FirstEnergy Nuclear Operating Company

**Subject: Beaver Valley Power Station, Unit Nos. 1 and 2
BV-1 Docket No. 50-334, License No. DPR-66
BV-2 Docket No. 50-412, License No. NPF-73
Supplemental Information for License Amendment Request Nos. 334
and 205 (TAC Nos. MD4290 and MD4291)**

Revisions to License Amendment Request (LAR) Nos. 334 and 205

Figure D-7:
Available NPSH for Unit 1 RS and LHSI Pumps

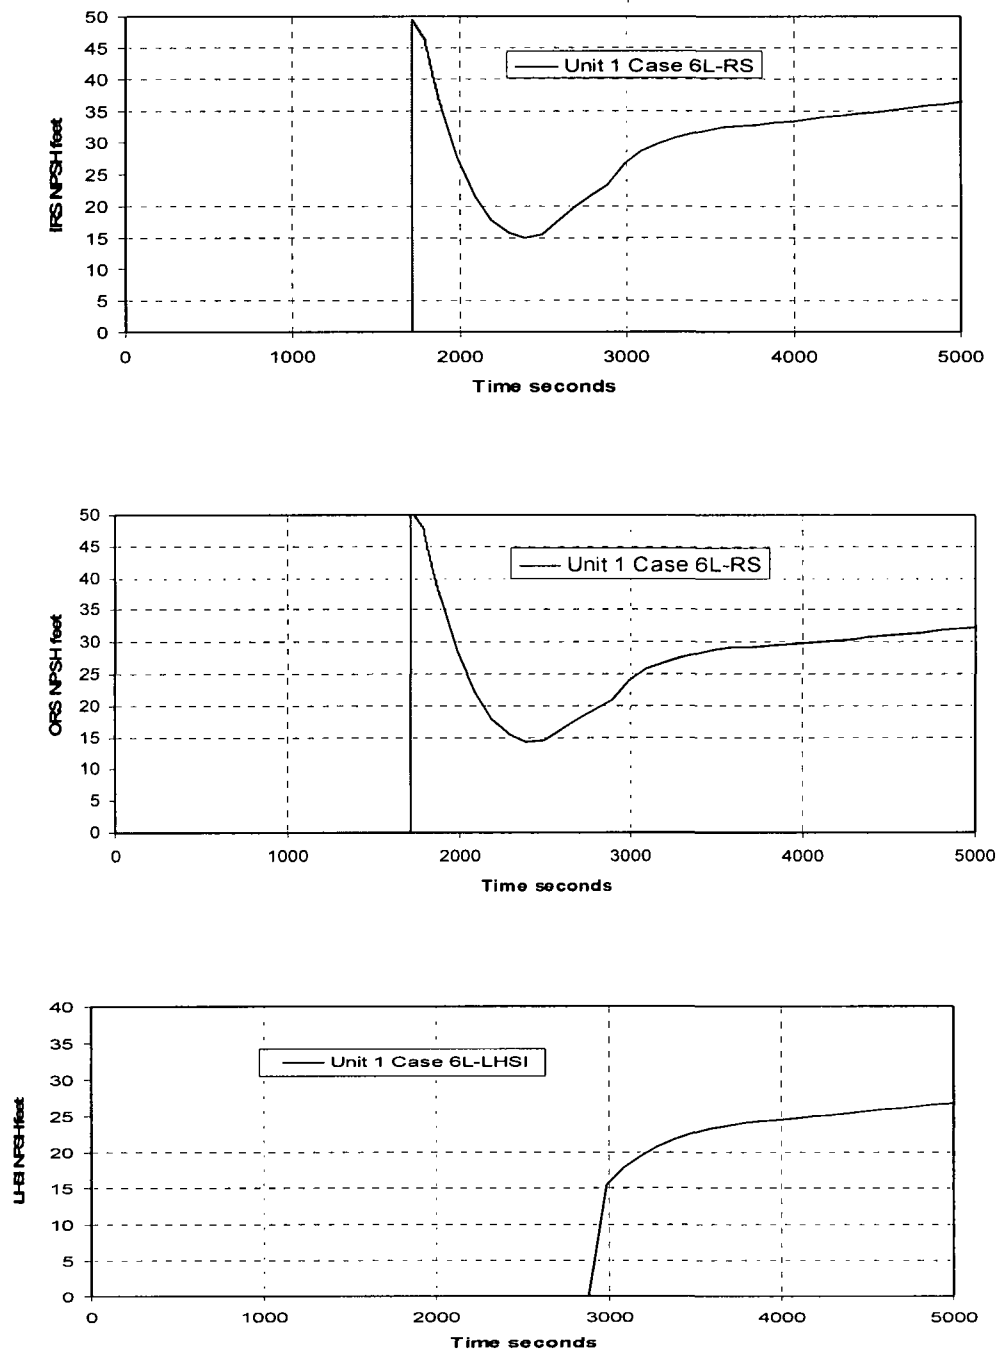
Tables D-9 and D-10 show the limiting NPSH results for the RSS and LHSI (Unit 1 only) pumps for Unit 1 and Unit 2, respectively. The available NPSH transient results for the most limiting cases are shown in Figures D-7 and D-8. Consistent with the current licensing basis, Unit 1 continues to credit containment overpressure for calculating available NPSH. At Unit 2, the analysis assumes that the sump vapor pressure is equal to containment pressure consistent with the Standard Review Plan Section 6.2.2 guidance. This is also consistent with the current licensing basis.

The Unit 1 results show a decrease in the available NPSH for the Inside Recirculation Spray (IRS) pumps and an increase for the Outside Recirculation Spray (ORS) pumps. This is primarily due to the modeling change for the direct QS injection flow as discussed above in the input changes section. The minimum NPSH margin for the RSS pumps is 4.3 feet. The Unit 1 LHSI pump available NPSH decreases when compared to the current analysis. This is due to the higher sump temperature (and vapor pressure) at switchover to cold leg recirculation. The minimum NPSH margin for the LHSI pump is 5.6 feet.
